**RE: Submission on Amendment C274card Officer South Employment Precinct Structure Plan**

Ethos Urban continue to act on behalf of Galileo Group (Galileo) who control the land holding at 190 Officer South Road (the site) within the Officer South Employment Precinct Structure Plan (PSP).

This submission responds to the release of draft documents relating to Planning Scheme Amendment C274card and the issues and implications for the site.

**Figure 1** Existing PAO Area

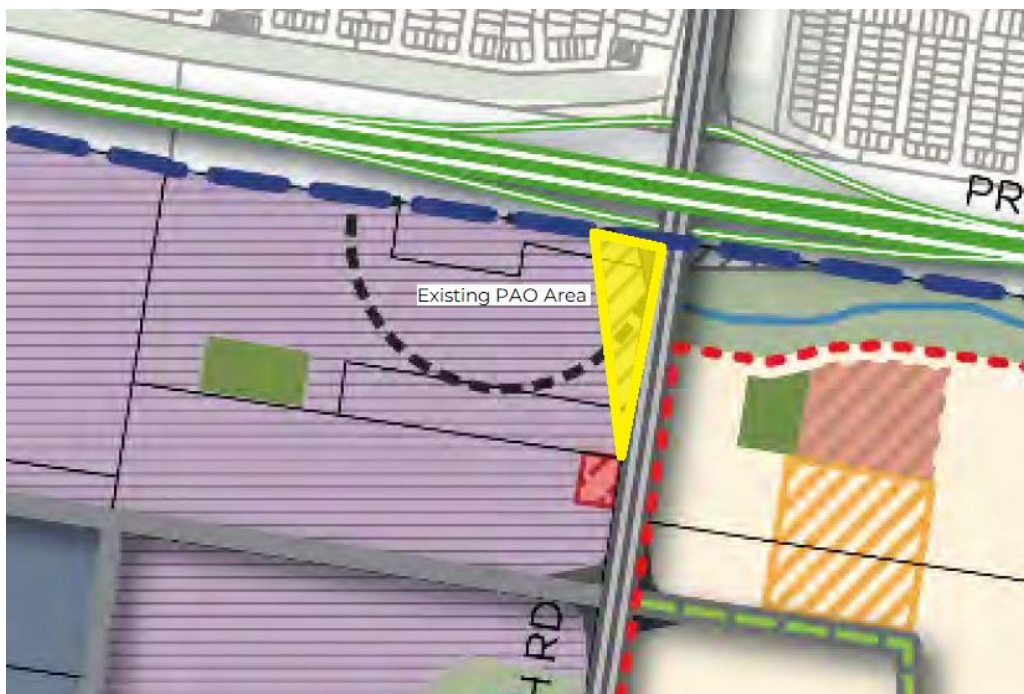
It is understood that the western bound on-ramps to the Princes Freeway from Officer South Road have been delivered. A Public Acquisition Overlay (PAO) remains on the site, despite the ramps having been delivered to an ultimate standard (Figure 1). Given that this ramp has now been constructed in the ultimate configuration the balance of the PAO is no longer required. This land should be acknowledged as surplus, removed from the PAO and shown as developable on the PSP. This should occur as part of this Amendment process and any further consultation required to enable the removal of the PAO should occur prior to gazettal of the PSP.

The PAO at 190 Officer South Road has an approximate area of 6,500m<sup>2</sup>. It also affects the properties to the north and south.

Galileo intend to commission a traffic engineering memo to confirm the strategic justification for the removal of the PAO.

**Figure 2** Gap in Open Space Provision

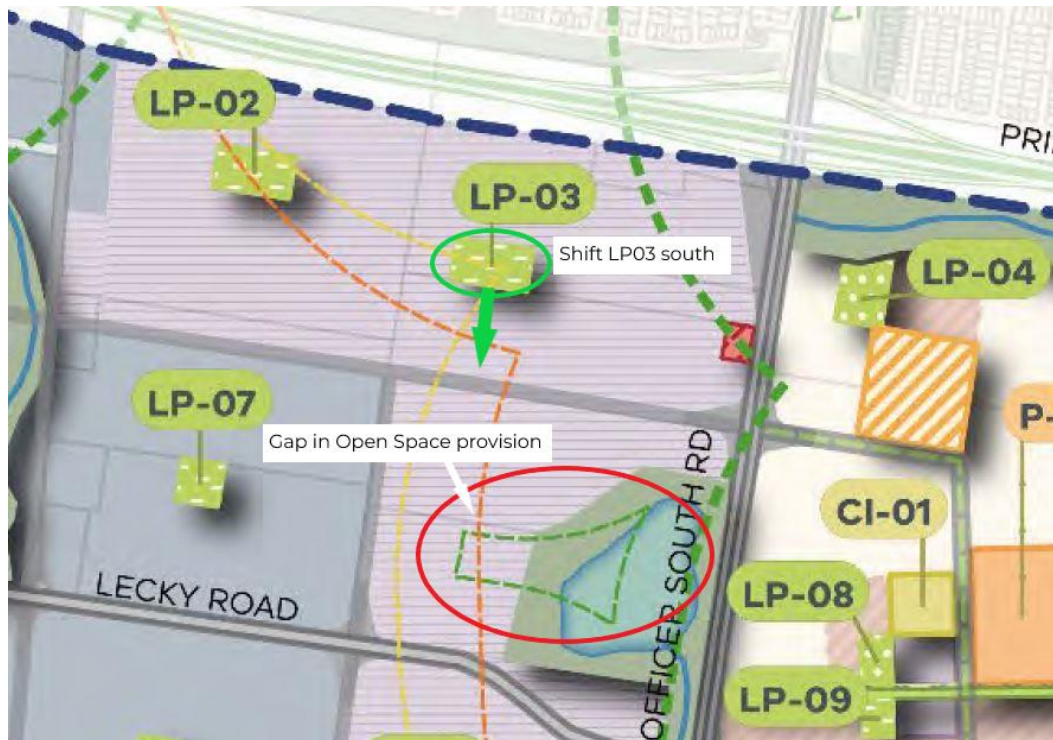
Public Open Space in the form of a Local Park (LP-03) is proposed to be located within the site. The Open Space and Community facilities Plan (Plan 6 of the draft PSP) demonstrates that this does not provide the best access and distribution of open space assets within the PSP and indicates a missing public open space catchment area south of the site and north of Lecky Road. It is submitted that LP-03 should be relocated further south of the site and we suggest a preferable location would be adjacent the future connector road, conceivably aligning with the proposed drainage reserve in this location. The location of LP-03 in this location will provide better distribution and reduce any gap in the public open space catchment further south of the site (Figure 2).

Figure 3.3: Pakenham wind rose (Source: CEE Report, May 2022)

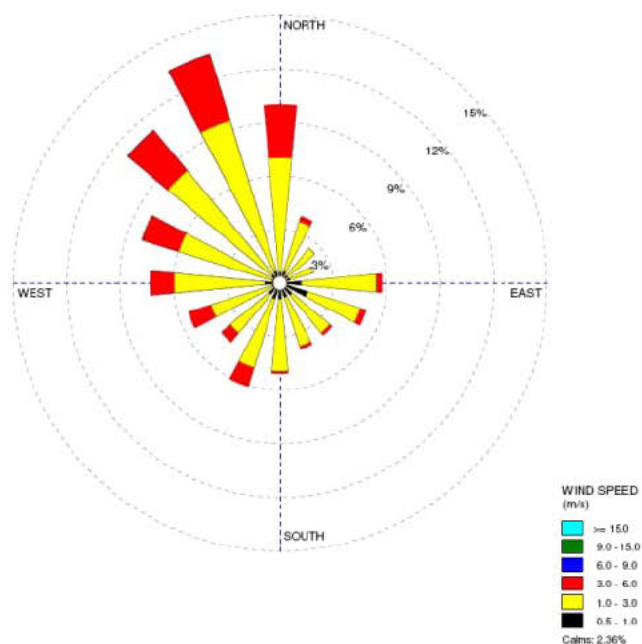
The CEE Report included a wind rose from Pakenham based on data from the Bureau of Meteorology (BoM) (Figure 3.3). Review of the BoM website indicates that a station at Pakenham is not part of the BoM automated weather station network and hence the Pakenham data is not publicly available. Although the Pakenham wind data cannot be independently verified, based on local knowledge from T+T's previous project experience in the area, the local wind conditions at Officer South are likely to be dominantly blowing from the eastern and northwestern directions, thereby exhibiting a stronger bi-directional wind rose than currently shown in the Pakenham wind rose. These dominant wind directions are likely influenced by the geographical features as shown in Figure 3.4:

The Pakenham wind rose from the CEE Report shows dominant north westerlies and easterlies to a lesser degree; further analysis is provided in Section 7.3.3. Overall, if dominant winds at Officer

South are blowing from the northwest or from the east, some sections of the Subject Land will be directly downwind of the SPS, meaning that there is a higher potential of odour impacts than if the Subject Land is upwind of the SPS most of the time.
